NOTICE OF ADDENDUM  
ADDENDUM NO. 2  
CONTRACT NO. 8119

S. BRYAN STREET, DALEY DRIVE, JAMES STREET AND THORP STREET  
RECONSTRUCTION DISTRICT – 2018

**Addendum #1 referenced several plan sheets that were not attached to the addendum. See attached for the revised plan sheets.**

ELECTRICAL SITE PLAN

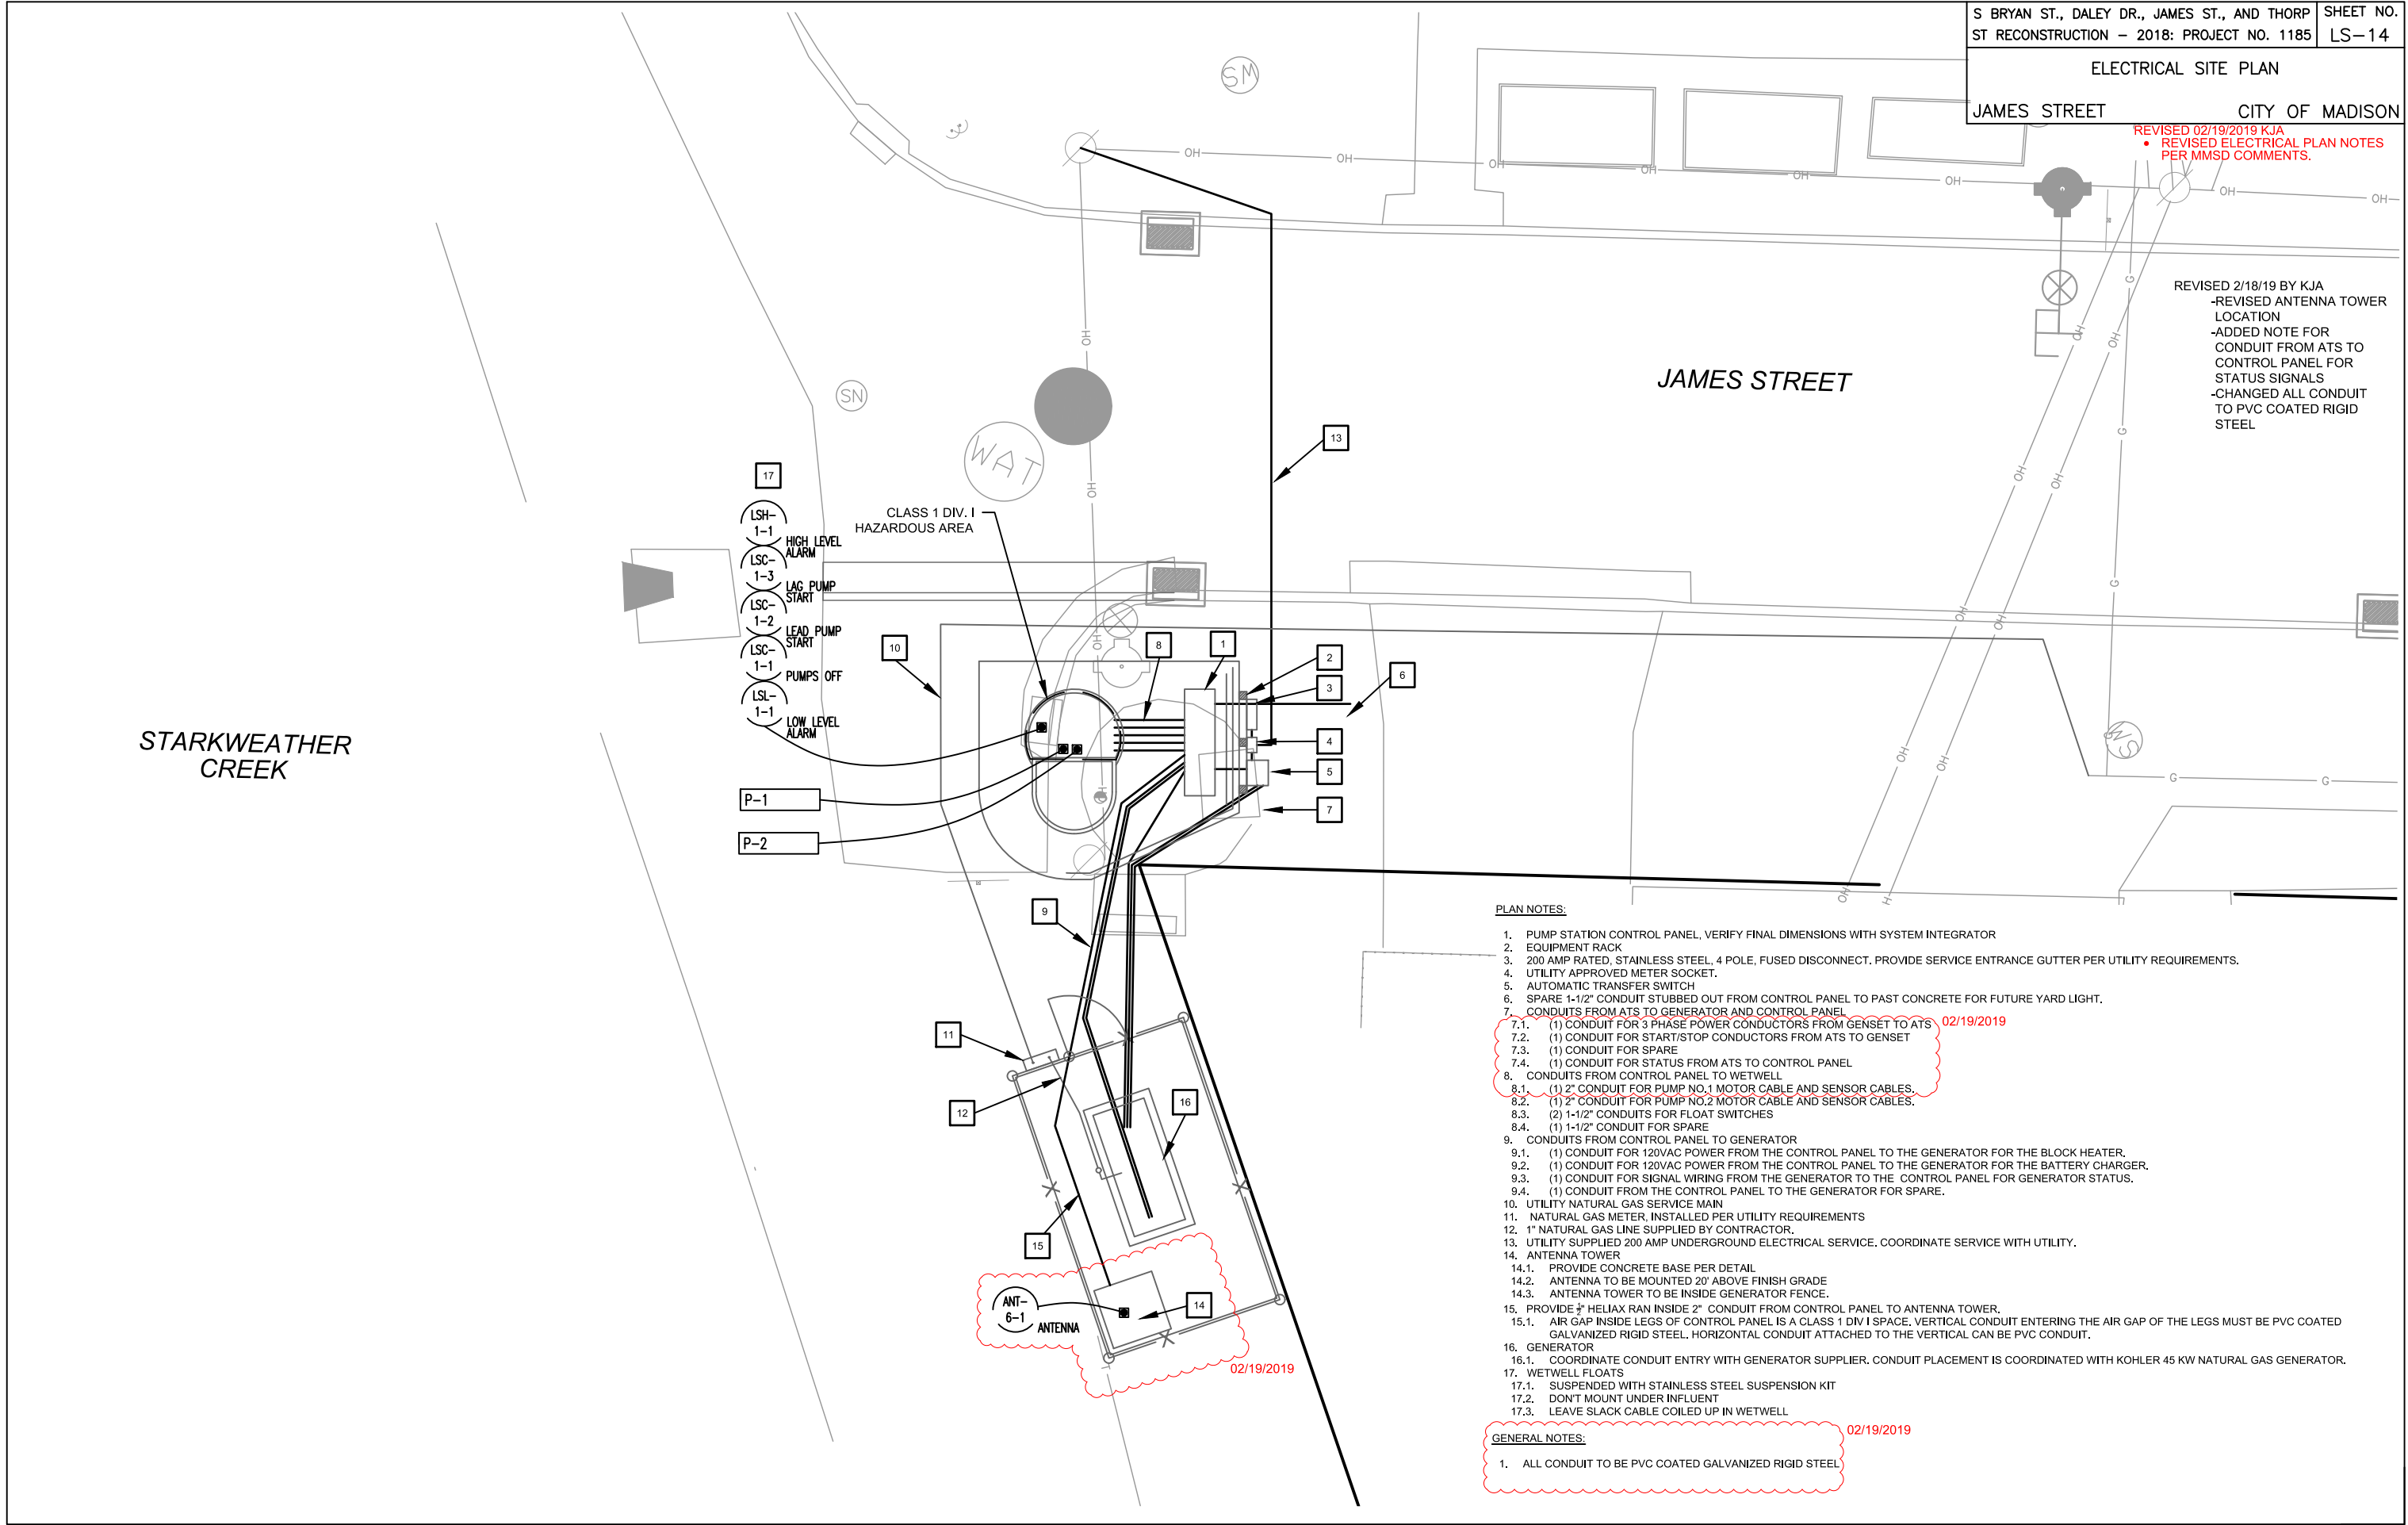
REVISED 02/19/2019 KJA  
 • REVISED ELECTRICAL PLAN NOTES PER MMSD COMMENTS.

REVISED 2/18/19 BY KJA  
 -REVISED ANTENNA TOWER LOCATION  
 -ADDED NOTE FOR CONDUIT FROM ATS TO CONTROL PANEL FOR STATUS SIGNALS  
 -CHANGED ALL CONDUIT TO PVC COATED RIGID STEEL

SCADA OVERVIEW  
 JAMES STREET CITY OF MADISON

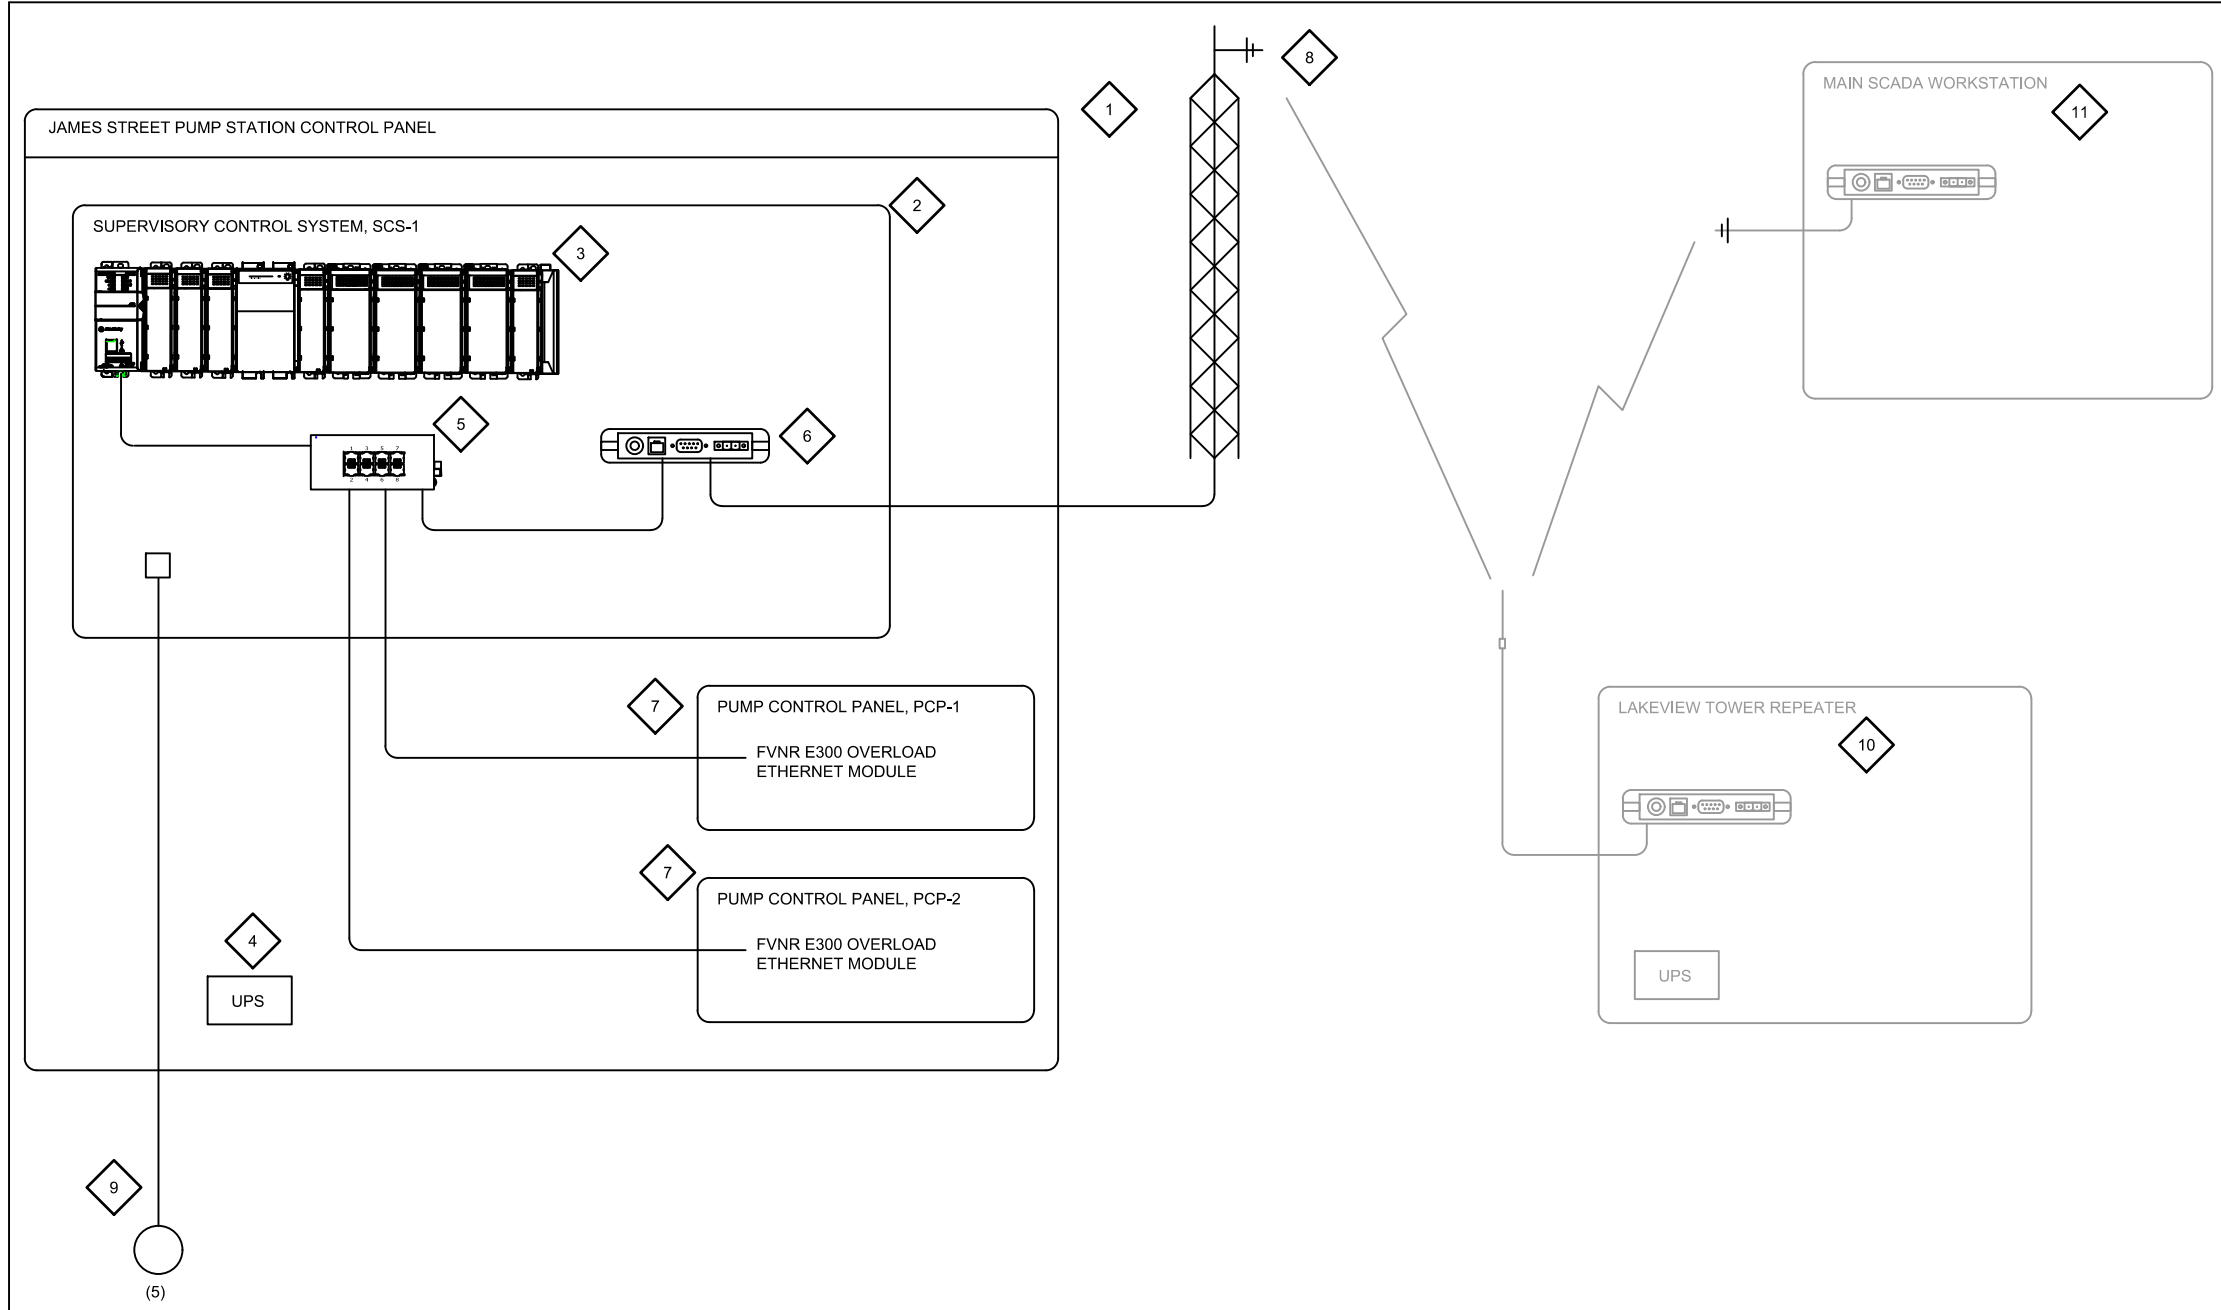
REVISED 02/19/2019 BY KJA  
 • REVISED NOTE 8 FOR OWNER FURNISHED ANTENNA EQUIPMENT.  
 • DELETED STATION HAND/AUTO AND START/STOP PUSHBUTTON.

ELECTRICAL ONE-LINE  
 JAMES STREET CITY OF MADISON

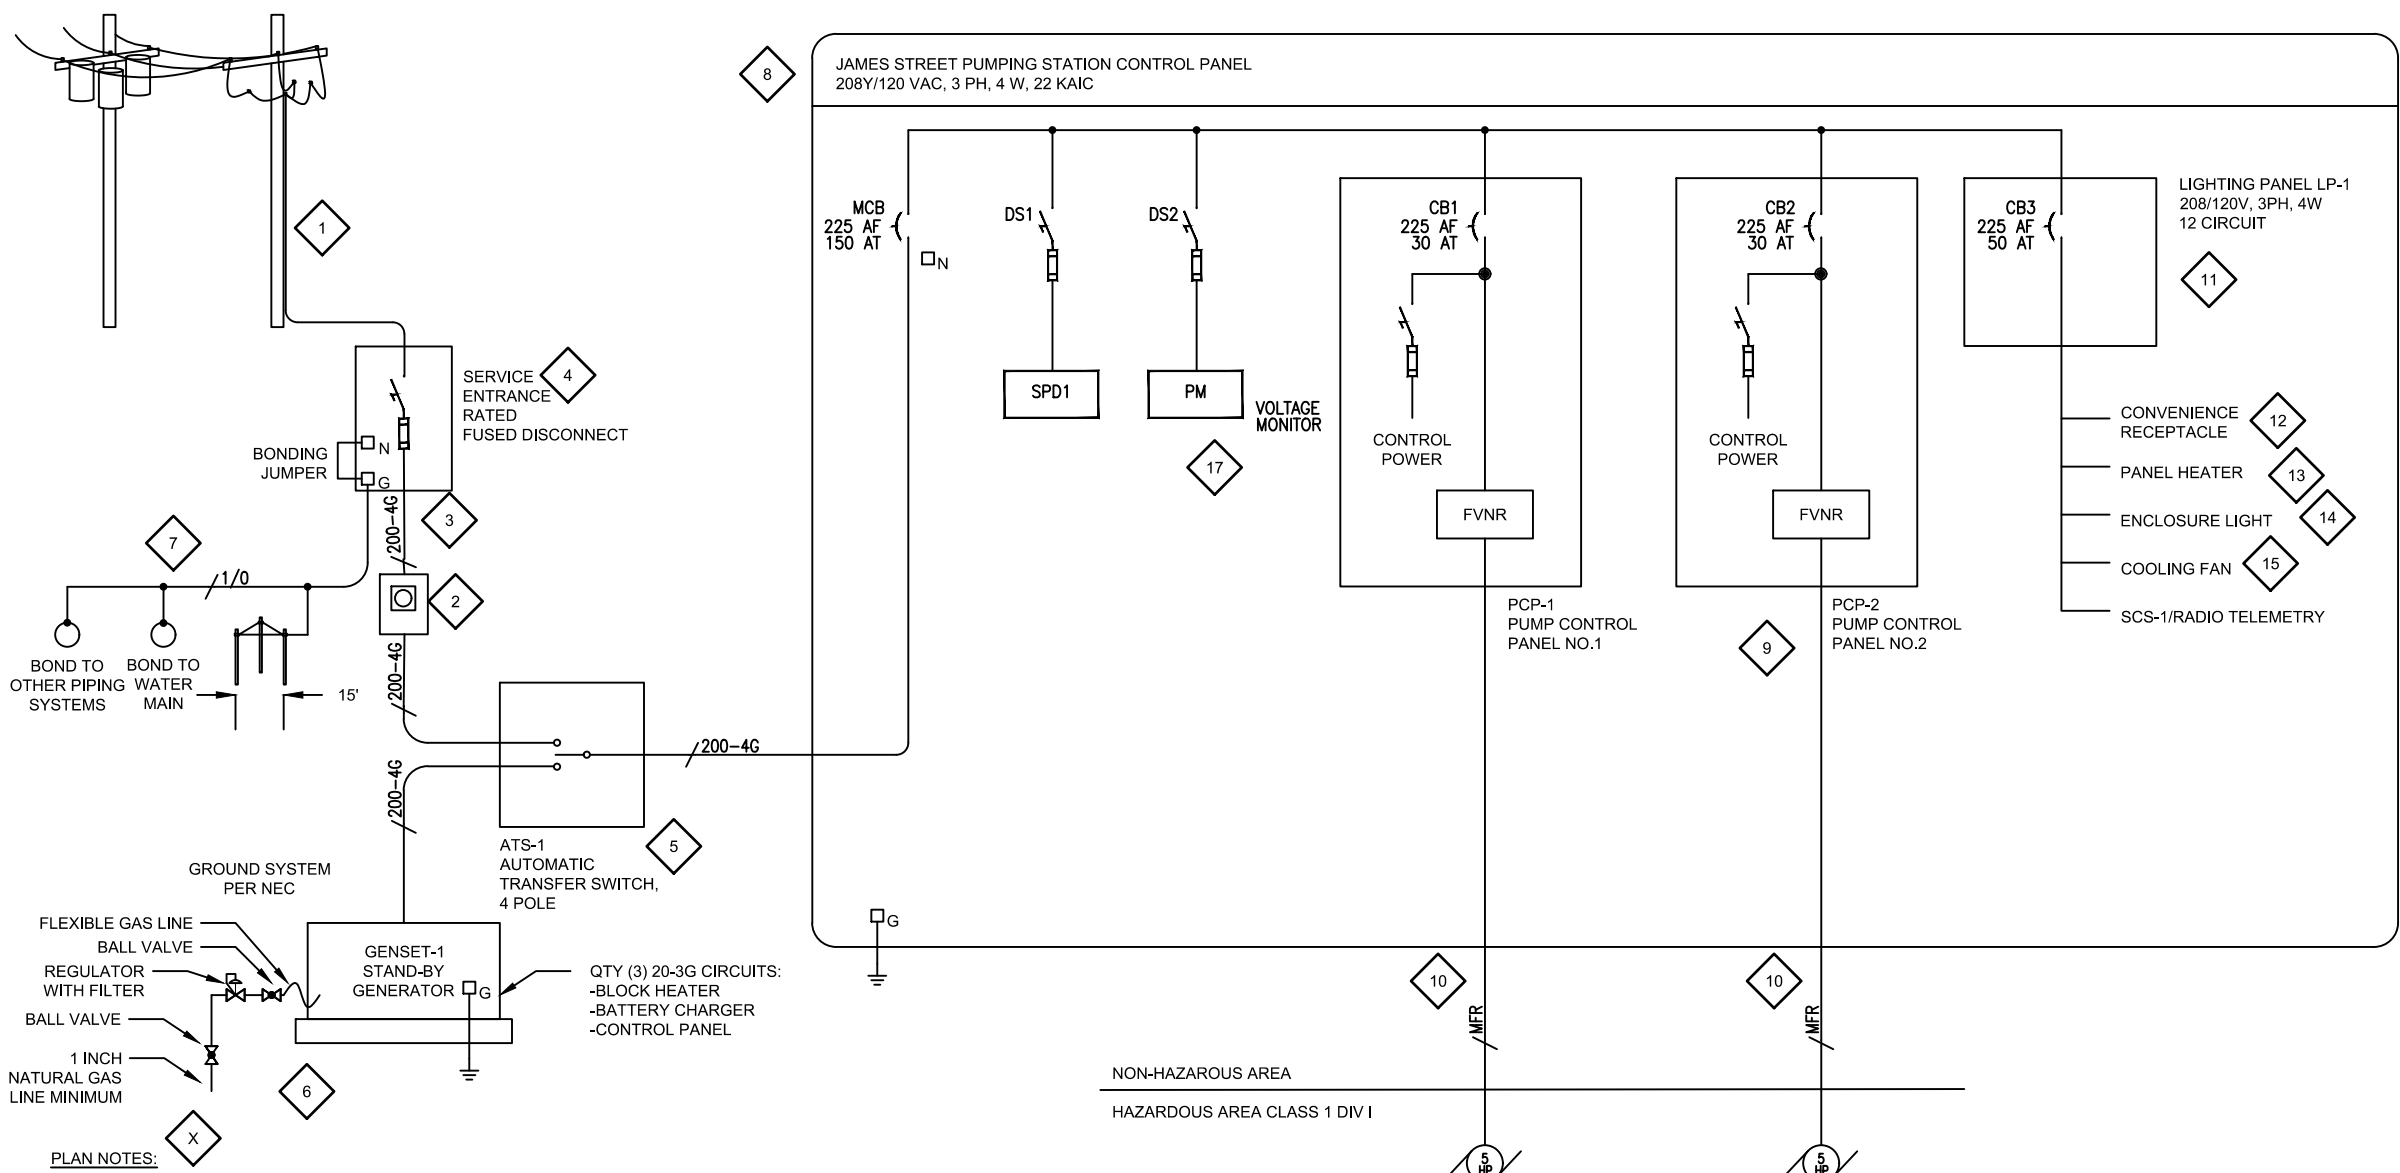
REVISED 02/19/2019 BY KJA  
 • ADDED NOTE TO GENERATOR TO GROUND PER NEC CODE.

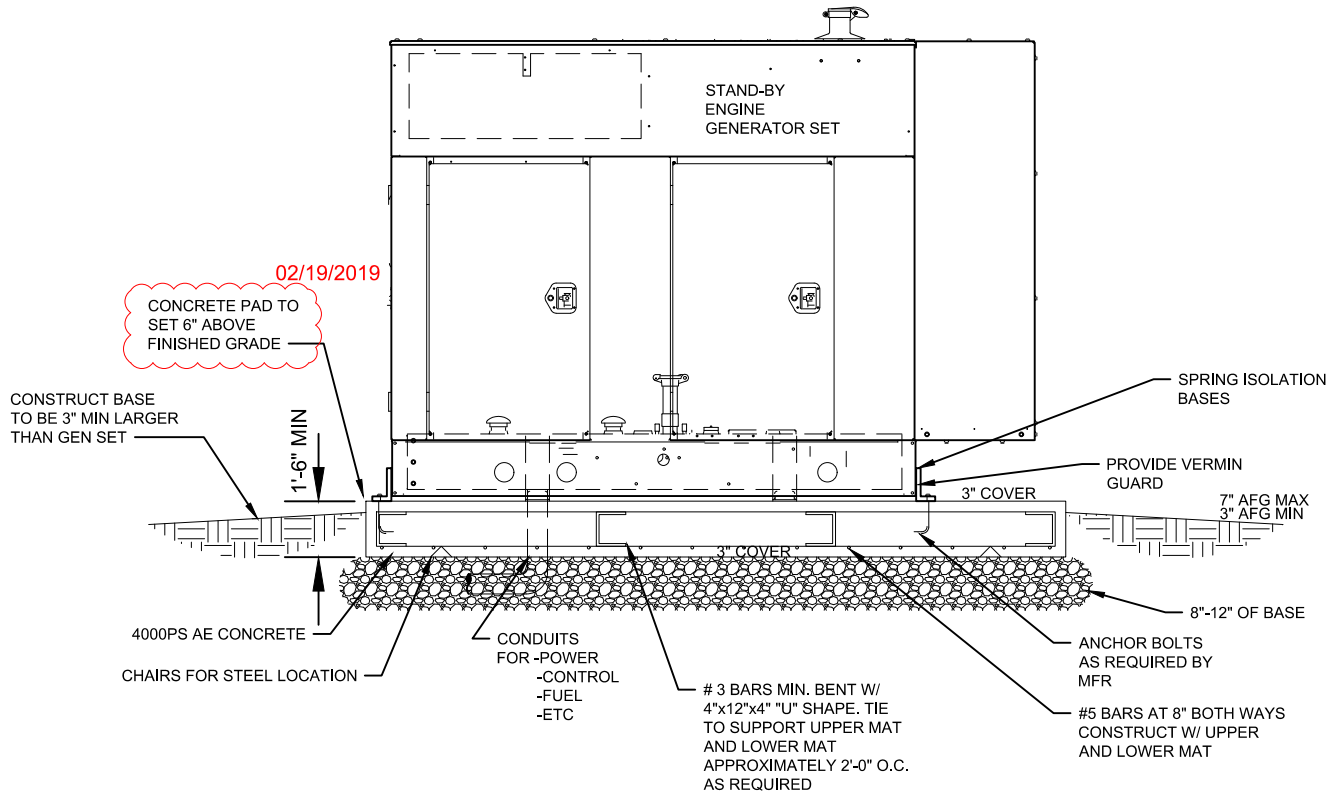
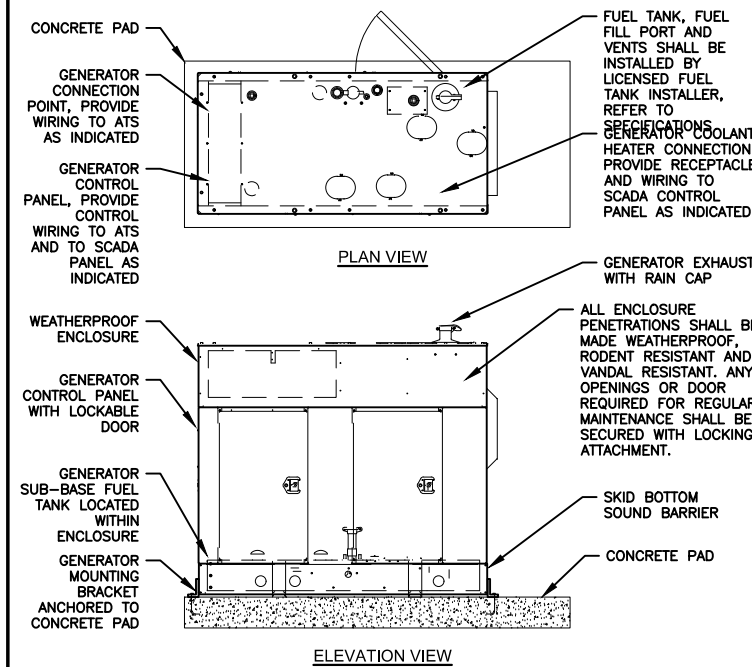
REVISED 02/19/2019 BY KJA  
 • REVISED GENERATOR PAD DETAIL.  
 • REVISED FREE STANDING CONTROL PANEL DETAIL.
